# Access Compliance Report

## Public Rights-of-Way

Intersection ID: 31905	Main Street: PALOMAR_MOUNTAIN_DR	Cross Street: STOWE_DERBY_DR	Location: NE
ADA ID: 67091258DF15	Ramp Type: BlendTrans2	Initial Pass/Fail: Fail	Overall Compliance: No
Severity Score: 10			
Codes/Mitigation Info/Possible Solution		Field Measurements/Component Compliance

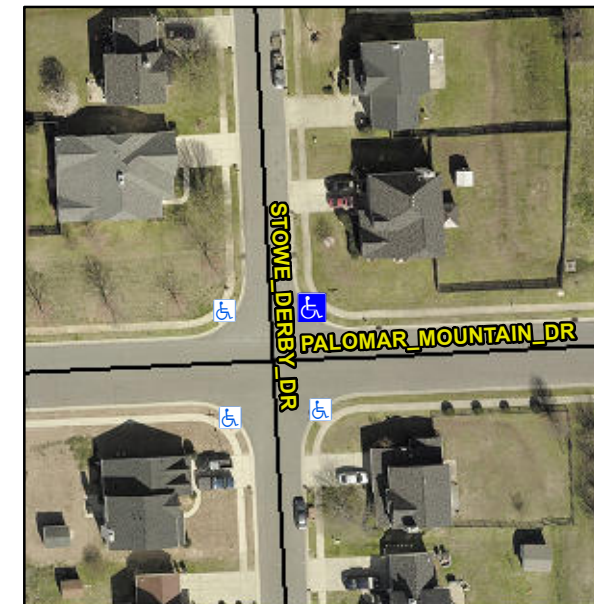
**Remove & Replace Curb Ramp With Two New Directional Ramps or Equivalent.**

**Not Found, R304.5.1, R304.5.3**
